Herrick, Will
Campton, KY
Page 12 of 108

The environmental impact of an IGCC plant is a function of the thermal and chemical character of the facility. Section 3.1.2 should address the temperature profile of the pyrolytic products. Examples of the types of information missing are offered below:²⁴

Example flow rate and temperature regime diagram.
BGR/L GASIFICATION BASE CASE Page 4

Figure 4.4 Temperature Profile of ARBRE Gasification System

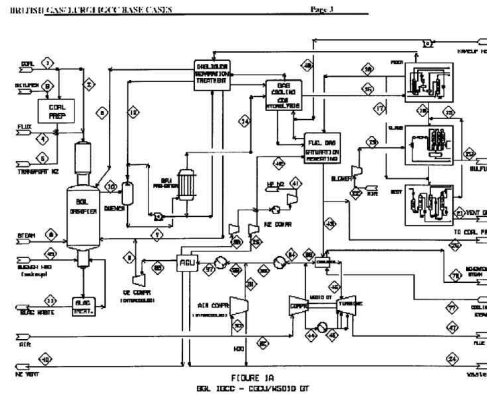
In the absence of information like that shown below, no analysis can be made about the fate of constituents. It is bordering on travesty that DOE published a DEIS absent of the essential design information needed to make any estimate of environmental impact.

The process diagram included as Figure 3.1.1-1 in the EIS was not intended to be a detailed construction drawing, but to represent a general depiction of the overall process. KPE states that the specific details of the nature and degree of aqueous effluent cannot be identified until the plant design is in more advanced stages. Prior to treatment, this waste stream may include pollutants such as metals, tars, and oils. However, as stated in Section 5.8, Water Resources and Water Quality, treated wastewater is expected to contain conventional pollutants such as nitrogen, phosphorus, total dissolved solids, and biological and chemical oxygen demand. Pollutant discharge
